### CITY OF BLOOMINGTON PLAN COMMISSION October 12, 2020 at 5:30 p.m.

CASE #: ZO-20-20 **STAFF REPORT – Second Hearing** DATE: October 12, 2020 **LOCATION: 301 E. Brownstone Drive**

Subject: ZO-20-20: The Standard at Bloomington LLC, Brownstone Terrace Apartments

#### 1. LANDSCAPE PLAN

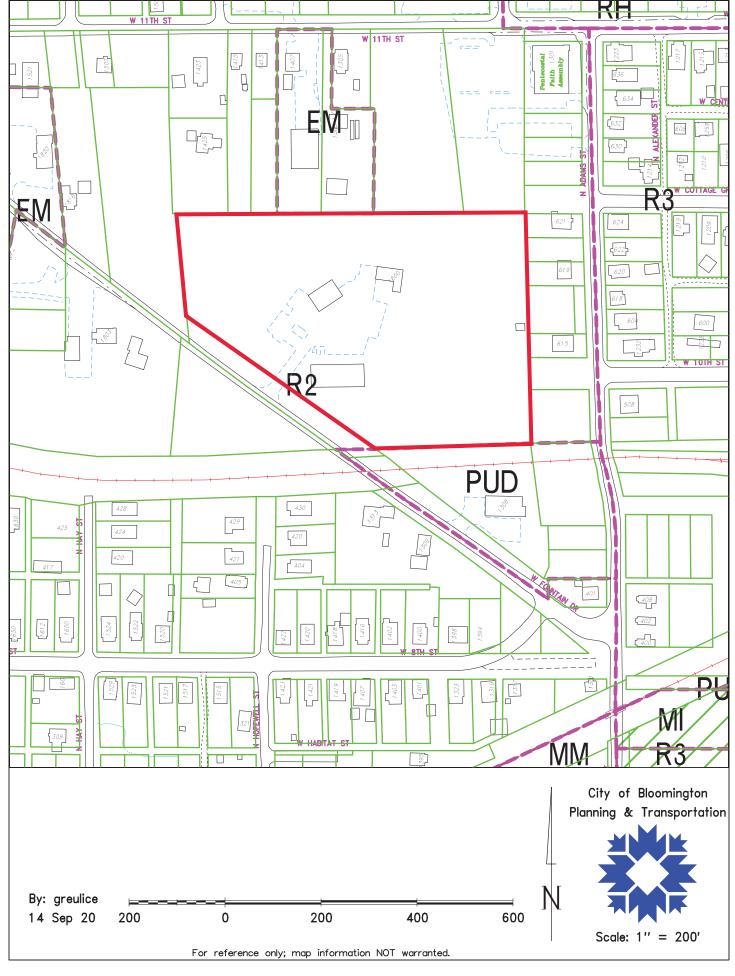
The Landscape Plan needs some revisions before a building permit can be issued.

a. The area labeled "woods" on the plan sheet C-101 is a closed-canopy wooded area, and as such should be designated as Conservation Easement (CE) according to Bloomington Municipal Code (BMC) 20.04.030(i), Tree and Forest Preservation; 20.05.040, Easements; and 20.05.040(e), Standards for Specific Easement Types, (9) Conservancy Easement. The CE shall be developed using all of the Conservation Easement regulations.

b. Within the CE lie two other easement areas; Karst Conservation Easements. The sinkhole on the west side of the property is already labeled and protected, but needs to be recorded. There is a second sinkhole on the east side of the site that is shown by contour lines, but is not yet delineated as a Karst Conservation Easement (KCE). A KCE needs to be surveyed and recorded. These shall adhere to the BMC 20.04.030(g), Karst Geology; and 20.050.040, Easements; and 20.05.040(e) Standards for Specific Easement Types (97) Karst Conservancy Easement. The KCEs shall be developed using all of the Conservation Easement regulations.

#### 3. BUFFER YARD

With this change in zoning to an Employment (EM) zoning district, it will adjoin properties that are zoned single-family residential. This requires a Type 3 buffer yard. A Type 3 buffer yard is 20 feet wide for the length of the property. The EC realizes that much of this is already wooded, but believes the buffer yard still needs to be delineated on the plans.

- 1. Revise the Landscape Plan prior to receiving a building permit.
- 2. Adhere to BMC 20.04 and 20.05 for Conservation Easements.
- 3. Delineate a Type 3 buffer yard along the length of the eastern border of the property on the site plan associated with the requested building permit.

## 1.) LANDSAPE PLAN

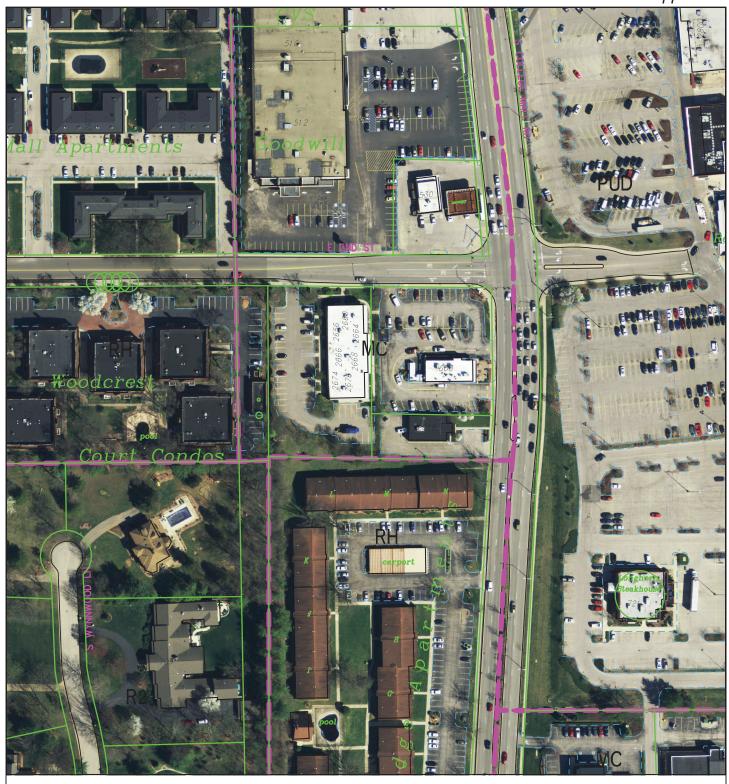
The Landscape Plan needs some revisions prior to the Petitioner receiving a Grading Permit.

## 2.) GREEN BUILDING

Using an existing building to add on to, is already a better green practice than demolishing it altogether. The EC recommends that the Petitioner continue on with that green attitude and employ other green building features. This would be a perfect building for Photo Voltaic Cells to provide the electricity.

- 1.) Revise the Landscape Plan prior to requesting a Grading Permit.
- 2.) Add some green building practices.
